Intel[®] Mobile Celeron[™] Processor at 466 MHz, 433 MHz, 400 MHz, 366 MHz, 333 MHz, 300 MHz, and 266 MHz Specification Update

Release Date: December 2000

Order Number: 244444-021

Figure 2. Workaround Flowchart: SMBALERT#-Driven System

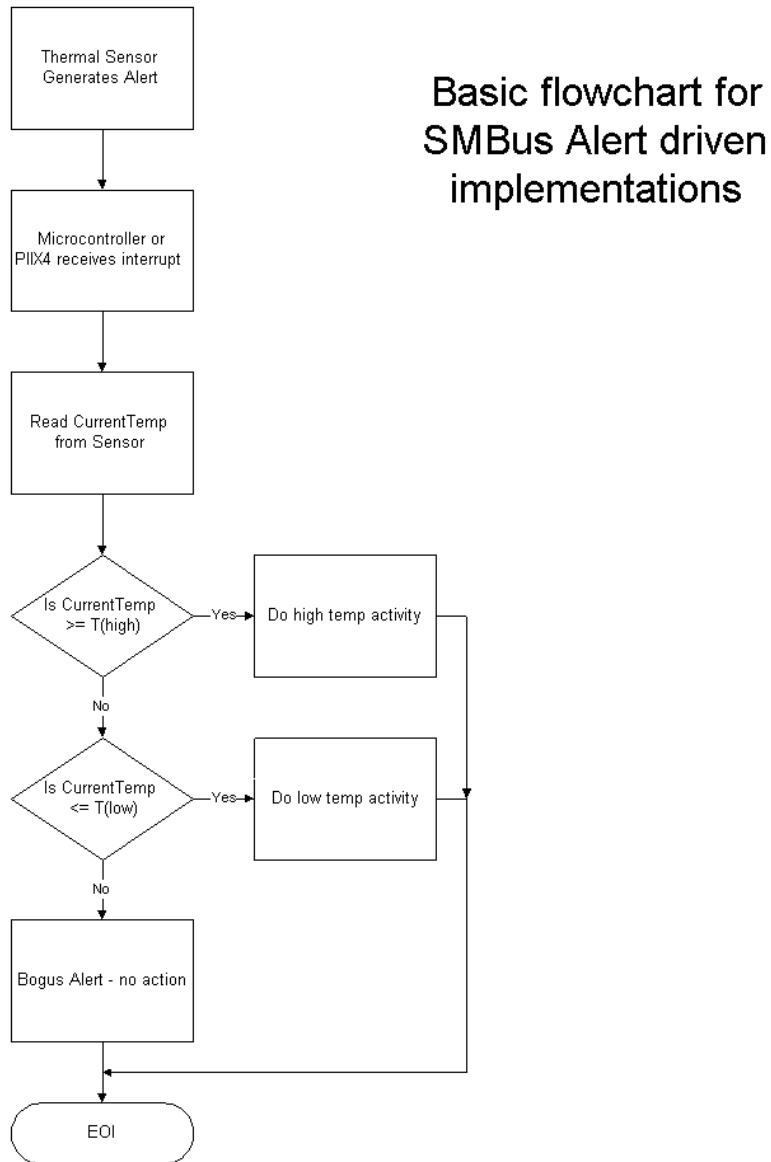
Problem: In certain SMBus configurations, when the thermal sensor is used in “hard wired alert” mode along with at least one other device on the bus, the thermal sensor may continue to send its address after losing a collision arbitration in response to an Alert Response Address (ARA) by the SMBus controller.

Implication: The SMBus controller may see an invalid address and the resulting response of the SMBus controller will vary from implementation to implementation.

Workaround: Remove any one of the five conditions listed above or:

Figure 5.3. Surface-Mount BGA1 Package—Top and Side View

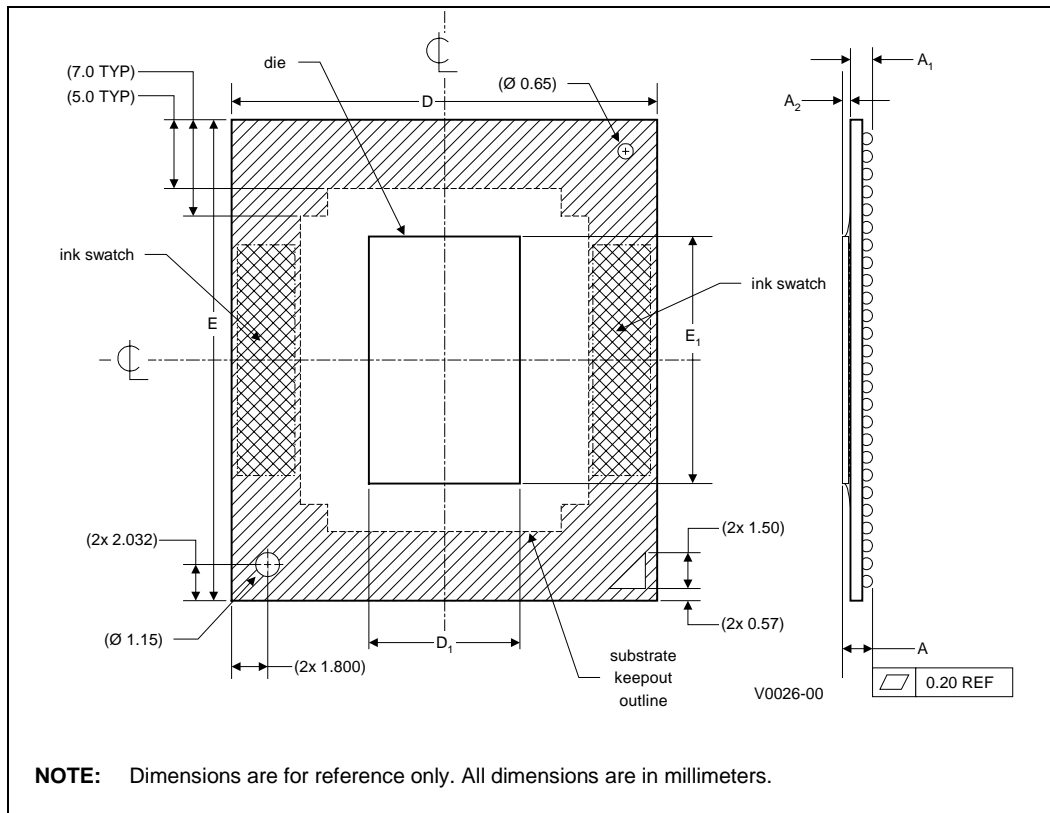
The following table and figures show the updated mechanical specifications for the BGA1 package, listed as Table 5.2, Figure 5.3 and 5.4, respectively, in the *Intel® Mobile Celeron™ Processor in BGA Package at 333 MHz, 300 MHz and 266 MHz* datasheet.

1. The number shown here is different from that in the 244444-004 version of this specification update. The maximum reference number is used.

Figure 3.3 Generic Clock Waveform

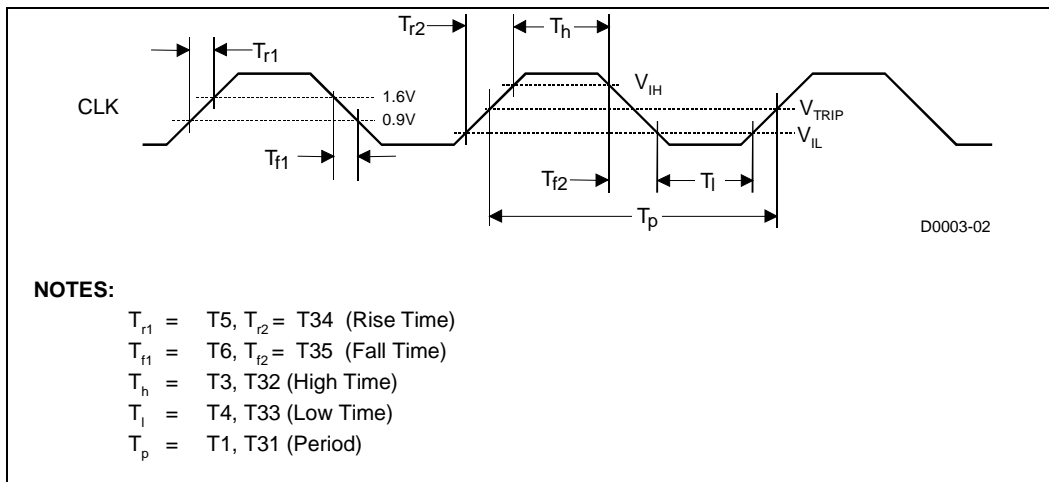
Figure 3.3 in the *Intel® Mobile Celeron™ Processor in μ PGA1 and BGA1 Packages at 366 MHz, 333 MHz, 300 MHz, and 266 MHz* datasheet (Order Number 245112-003) has been updated. The following figure is to replace the one in the above document.
